**IV. IMMEDIATE/HIGH PRIORITY RECOMMENDATIONS AUDITED**

**Location:** Ventura County Community College Dist. - MOORPARK COMMUNITY COLLEGE - P-Lot PS (Parking Structure) Top Level Near Elevators

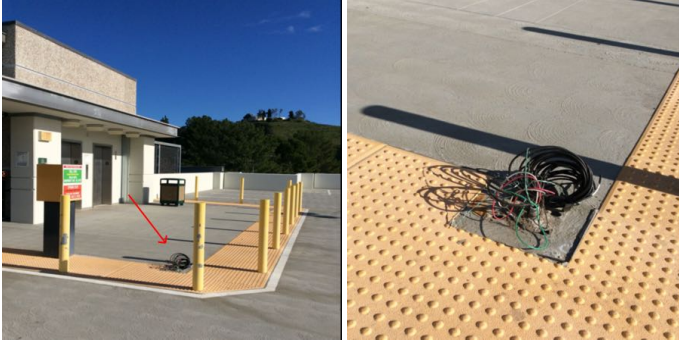
**Description:** The cables from a removed call box were left behind and may present a trip hazard and/or electrical hazard. Consider removing the cables to reduce the hazard. Note: This was reported to the Maintenance Department. As a temporary measure, a traffic cone was placed on top of the cables.

**Close Note:** On each level, the cables were covered. A yellow plastic post was installed for greater visibility.
